AERONAUTICAL CHARTING MEETING Charting Group Meeting – October 23 - 24, 2019

RECOMMENDATION DOCUMENT

FAA Control #19-02-339

Subject: LAHSO Rejected Landing Procedures

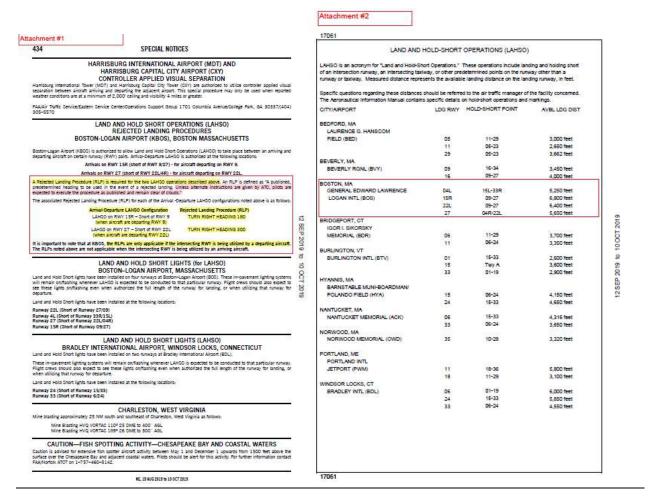
Several U.S. airports have specific Rejected Landing Procedures (RLP) associated with a LAHSO clearance. An example is Boston, MA – Logan (BOS) – See Attachment 1. This AIM paragraph does not mention the existence of published LAHSO rejected landing procedures, nor does it provide the location of these procedures which are only published in the FAA Chart Supplement's Special Notices. While the pilot is ultimately responsible to be familiar with all available information applicable to a flight, it would be helpful if the guidance on LAHSO would point the pilot to the location of these LAHSO rejected landing procedures.

FAA should publish any rejected landing procedures in the LAHSO entry in the FAA Terminal Procedures Publication (TPP) in addition to publishing them in the Chart Supplement, Special Notices.
